**Appendix 6.2: ABIA MASTER PLAN
SAFETY ASSESSMENT AREAS SRM
PANEL REVIEW**

Appendix 6.2: ABIA Master Plan Safety Assessment Areas SRM Panel Review

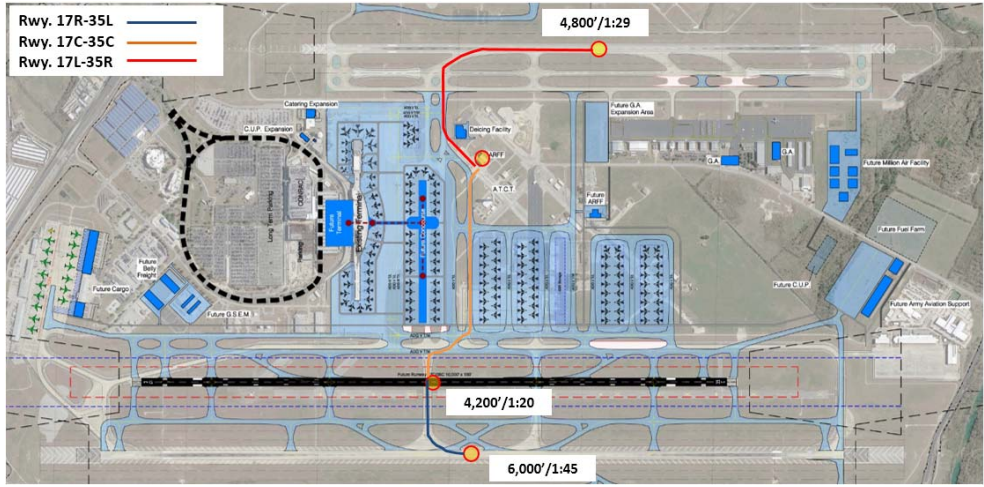
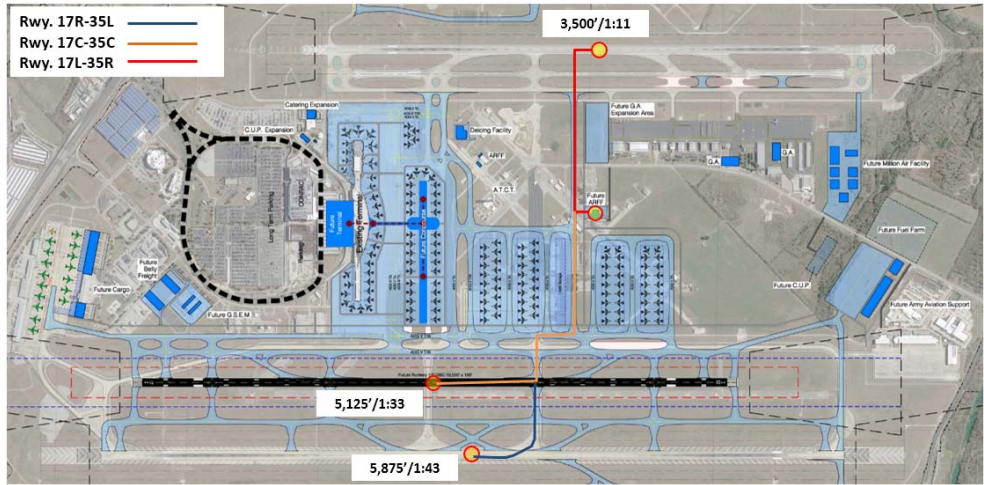
7.	Runway and Taxiway Geometry	Runway length	<p>10,000' runway vs a 9,000' Runway</p> <p>Was an analysis conducted that assessed a specific widebody to a specific destination as during the hottest day of August? (AC 150/5325-4B).</p>	<p>A runway length analysis was conducted in accordance with FAA guidance and is presented in Chapter 4, <i>Demand/ Capacity Facility Requirements</i>, of the 2040 Master Plan Report. A minimum length of 10,000 feet is recommended to accommodate the anticipated domestic aircraft fleet mix at maximum takeoff weight.</p>	<p>Concern does not create an ALP hazard.</p> <p>A runway length analysis determined that a 10,000-foot-long runway is needed to accommodate long-haul international flight destinations (cargo and commercial).</p>

#	AREA	BRIEF DESCRIPTION	DESCRIPTION OF CONCERN OR CHANGE INCLUDING BACKGROUND	DISCUSSION, DOCUMENTATION, REVIEW, OR RESPONSE	ACTIONS, RECOMMENDATIONS, HAZARD SHEET REFERENCE # (IF ANY)
				This length can also accommodate some of the international fleet mix (non-long-haul operations) and can be used if Runway 17R-35L is closed for maintenance.
